# Access Compliance Report

## Public Rights-of-Way

Intersection ID: 23309	Main Street: BRIDGEWOOD_LN	Cross Street: CARMEL_RD	Location:	N
ADA ID: E670CE747031	Ramp Type: PerpDiag	Initial Pass/Fail: Fail	Overall Compliance: No	Severity Score: 22.5

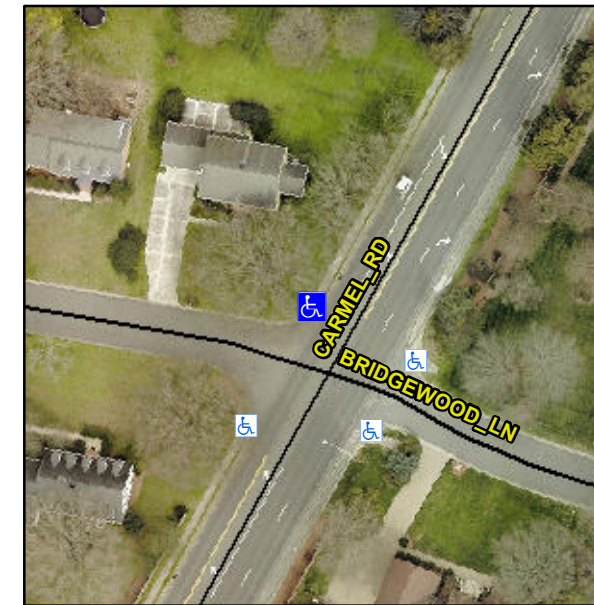
**Not Found, R304.5.1, R304.2.2, R304.5.3**

Compliance	Description	Data	Compliance	Description	Data
N/A	Ramp Length (in)	32.0	No	Ramp Slope (%)	11.3
No	Ramp Width (in)	40.0	No	Ramp XSlope (%)	3.1
N/A	Flare Type LT	N/A	N/A	Flare Type RT	N/A
N/A	Flare Slope LT (%)	N/A	N/A	Flare Slope RT (%)	N/A
N/A	Flare Traversable LT?	N/A	N/A	Flare Traversable RT?	N/A
N/A	Landing Length (in)	N/A	N/A	DWS Provided?	N/A
N/A	Landing Width (in)	N/A	N/A	DWS Contrast?	N/A
N/A	Landing Slope (%)	N/A	N/A	DWS Length (in)	N/A
N/A	Landing X Slope (%)	N/A	N/A	DWS Full Width?	N/A
N/A	Landing Curb? (Y/N)	N/A	N/A	DWS Offset (in)	N/A
N/A	Shared Landing?	N/A			
N/A	Gutter Ponding?	N/A	N/A	Gutter Slope (%)	N/A
N/A	Gutter Lip Ht (in)	N/A	N/A	Gutter X Slope (%)	N/A
N/A	Painted X Walk1?	No	N/A	Painted X Walk2?	No
	X Walk 1 Direction	To SW		X Walk 2 Direction	To SE
N/A	X Walk 1 Width (in)	N/A	N/A	X Walk 2 Width (in)	N/A
	X Walk 1 Slope (%)	1.9		X Walk 2 Slope (%)	5.7
	X Walk 1 X Slope (%)	4.5		X Walk 2 X Slope (%)	0.8

**Remove & Replace Curb Ramp With Two New Directional Ramps or Equivalent.**
